MARTIN COUNTY, FLORIDA

Building Permit Application No. BLD2025080317

NOTICE OF APPEAL

Pursuant to Article 10.12 of the Martin County Land Development Regulations, Appellant, **Cory Beaton**, hereby appeals the Final Administrative Decision of the County Administrator affirming the denial of Building Permit Application No. BLD2025080317.

COVER SHEET
SHEET
C-1

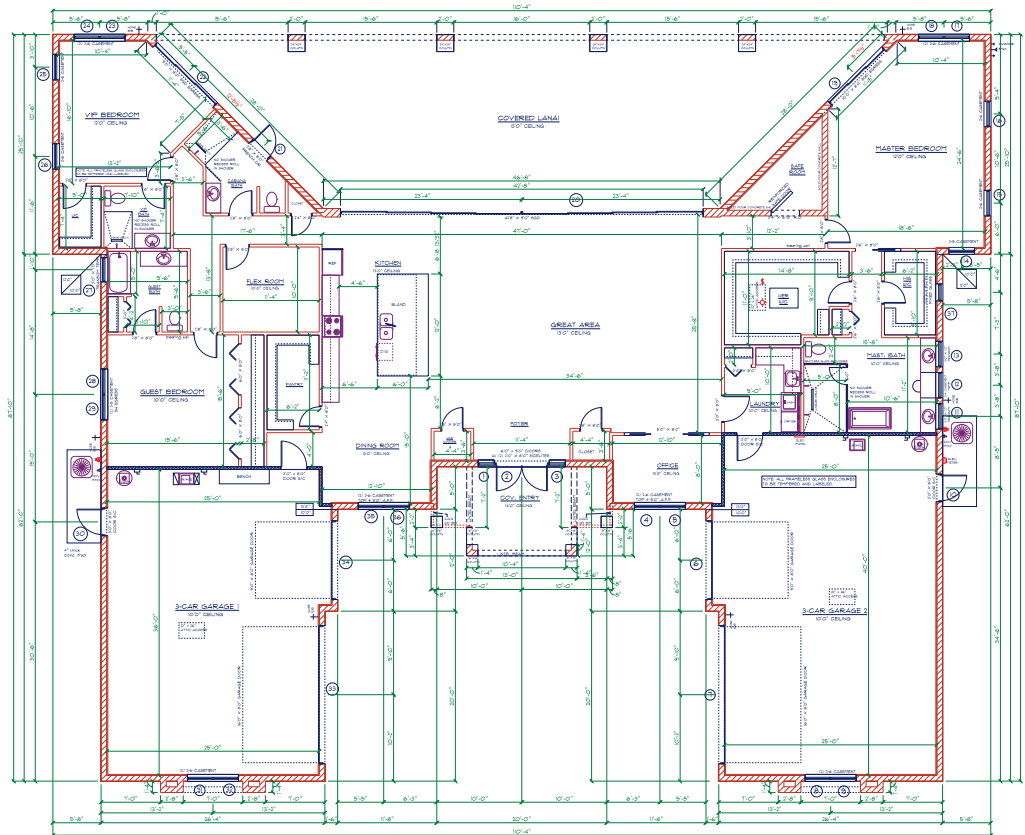
Last comment from reviewer: Sheet C-1 Job Location map was not revised to the correct address/location. Please correct.

- Address on plan sheets is inconsistent with the application address. (shows a palm beach county location)
- Job location map on sheet C-1 is inconsistent with the application address.
